# TRUCK, UTILITY, 1/4 TON GS LANDROVER, SERIES 2 AND 2A

106 MM AMMUNITION STOWAGE COMPARTMENT

MODIFICATION INSTRUCTION

FIG 1 - SPACER BRACKETS AND SIDE BRACKET

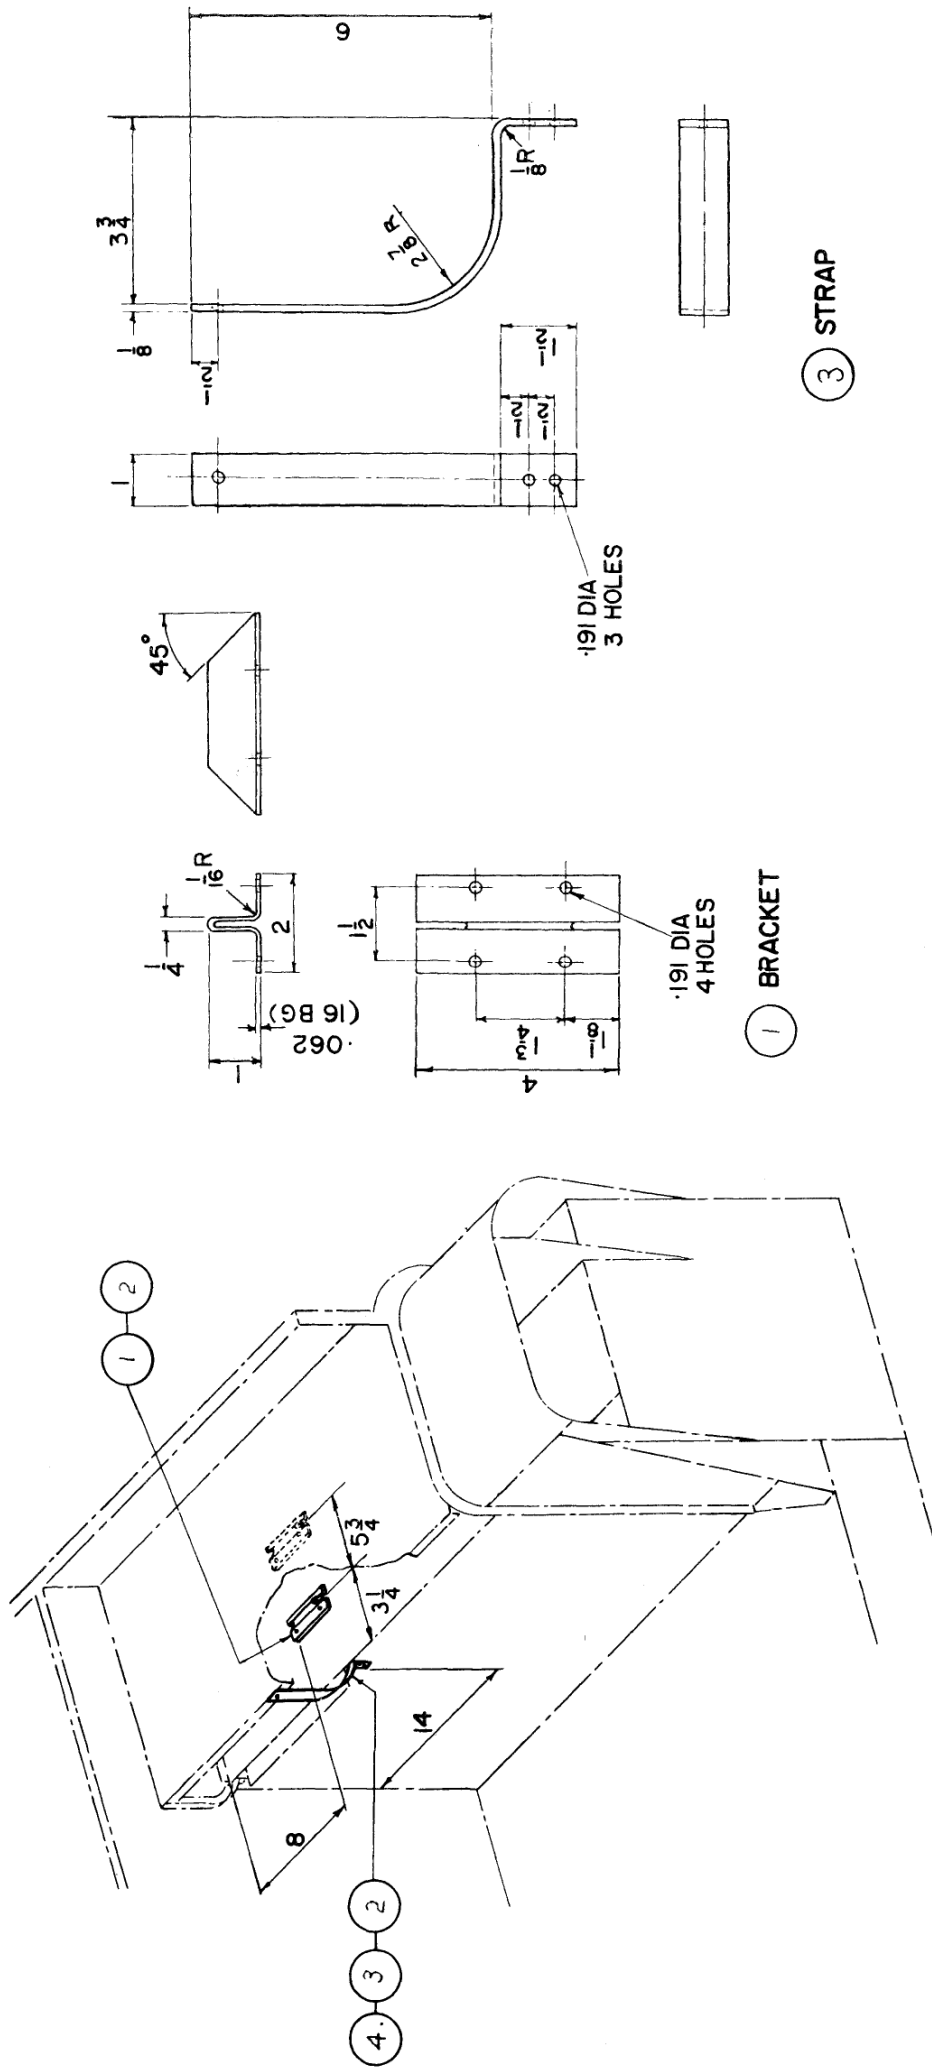
1. This instruction details the manufacture and fitting of spacer brackets to be riveted to the base of each ammunition compartment and curved brackets fitted to the middle length of the inboard side of the compartment to prevent the ammunition from moving in the stowage space.

7.
  - a. Manufacture the brackets as detailed in fig 1.
  - b. Drill the rivet holes using a No 11 drill, remove all sharp edges.
  - c. Remove the covers from the top of the ammunition compartments.
  - d. Position the brackets as shown in fig 1, mark the rivet holes, then drill using the No 11 drill.
  - e. Rivet the brackets in position.
  - f. Paint new work in accordance with WKSP B 700.
  - g. Replace the covers to the ammunition compartments.
8. On completion of this modification, the numeral "5" on the modification record plate is to be defaced in accordance with WKSP A 851.
